Access Compliance Report Public Rights-of-Way (Curb Ramps)

Main Street: SANTA_CLARA_AVE		Cross Street: YORBA_ST		Location:	SE
ADA ID: RPRK220127120345	Ramp Type: Type 4 - Parallel	Initial Pass/Fail: Pass	Overall Compliance: No	Severity Score:	0
Codes/Mitigation Info/Possible Solution			Field Measurements/Component Compliance

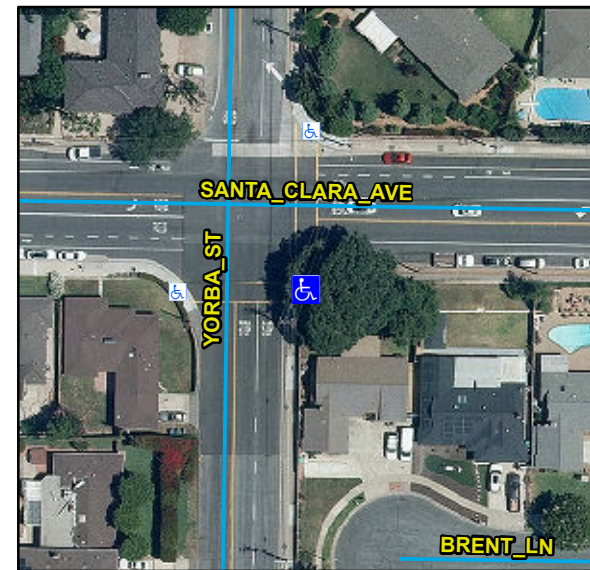
Compliance	Description	Data	Compliance	Description	Data
N/A	Ramp Length LT (in)	89	N/A	Ramp Length RT (in)	91
Yes	Ramp Width LT (in)	86	Yes	Ramp Width RT (in)	86
Yes	Ramp Run Slope LT (%)	5.7	Yes	Ramp Run Slope RT (%)	2.2
Yes	Ramp Cross Slope LT (%)	1.1	Yes	Ramp Cross Slope RT (%)	0.5
N/A	Landing Present	Yes	Yes	DWS Provided	Yes
N/A	Landing Length (in)	86	Yes	DWS Contrast	Yes
Yes	Landing Width (in)	48	Yes	DWS Length (in)	36
Yes	Landing Run Slope (%)	1.3	Yes	DWS Full Width	Yes
Yes	Landing Cross Slope (%)	0.8		DWS Offset Type	Single
N/A	Landing Movement Obstructed?	No	Yes	DWS Offset Left (in)	1
	Landing Movement Type	Curb	Yes	DWS Offset Right (in)	N/A
N/A	Landing Shared	No			
Yes	Clear Space	Yes			
Yes	Clear Space To Crosswalk (in)	48			
N/A	Marked Crosswalk 1	Yes	N/A	Marked Crosswalk 2	Yes
	Crossing 1 Direction	N		Crossing 2 Direction	W
	Marked Crosswalk 1 Width (in)	144		Marked Crosswalk 2 Width (in)	144
Yes	Ramp Inside Crosswalk 1	Yes	No	Ramp Inside Crosswalk 2	No

Restripe Crosswalk.
